Application at Nursery Fields, Land to the north of Chalcraft Lane, West Bersted (ref. BE/148/20/OUT)

**Appendix 1 Review of i-Transport Modelling prepared by Pell Frischmann
(dated 03 February 2021)**

Pell Frischmann		Project No. A13395
		Version No. Final
TECHNICAL NOTE	Project West Bersted	Date 16/02/2021
Subject Review of i-Transport Modelling		By Chkd S. Moody P. Smith

Figure 1: Observed traffic flows (November 2019) AM peak hour (8am to 9am)

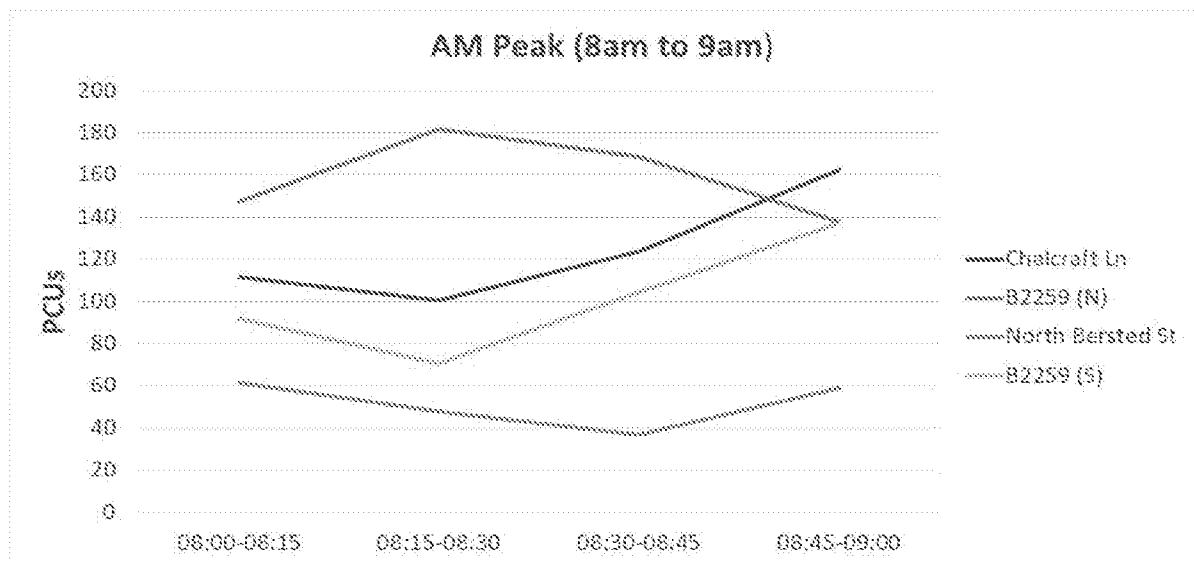
- 1.3 The i-Transport modelling uses the ONE HOUR data entry methodology which simulates a profile where the peak demand is in the middle 30 minutes of the modelled period. It is considered that it is more representative to model the junction using the DIRECT data entry methodology and it is assumed that i-Transport commissioned a survey that provided the data in 15 minute intervals during the peak periods.
- 1.4 The focus of this review is on the AM peak period due to known traffic congestion concerns at the junction. Consideration of the traffic profile across the period 8am to 9am for each of the entry arms to the double mini-roundabout shows that a ONE HOUR data entry would not accurately reflect traffic patterns at this junction. The profiles from the November 2019 survey are shown in Figure 1.

Figure 2: i-Transport junction measurements

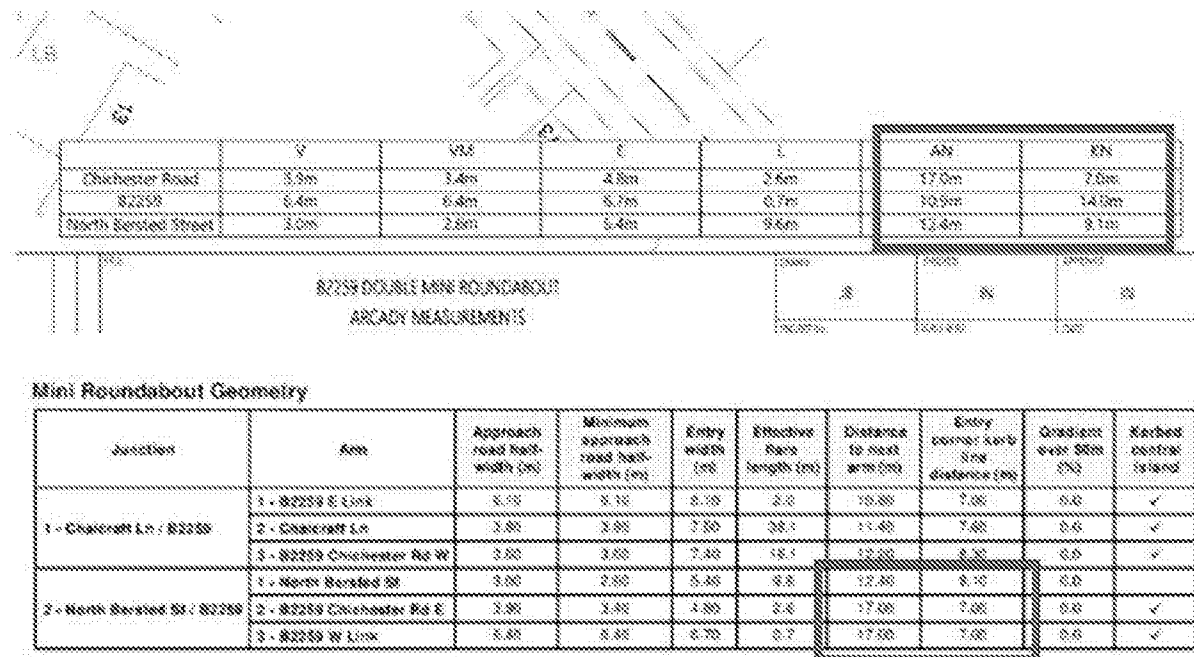
- 1.5 Review of the geometric inputs to the junction models has determined that two values shown on Drawing ITB14224-GEOM-003 do not match those input to the model (based on review of the model output files appended to the transport assessment report). These are highlighted in Figure 2.

- Review of the geometric inputs to the junction models has determined that two values shown on Drawing ITB14224-GEOM-003 do not match those input to the model.
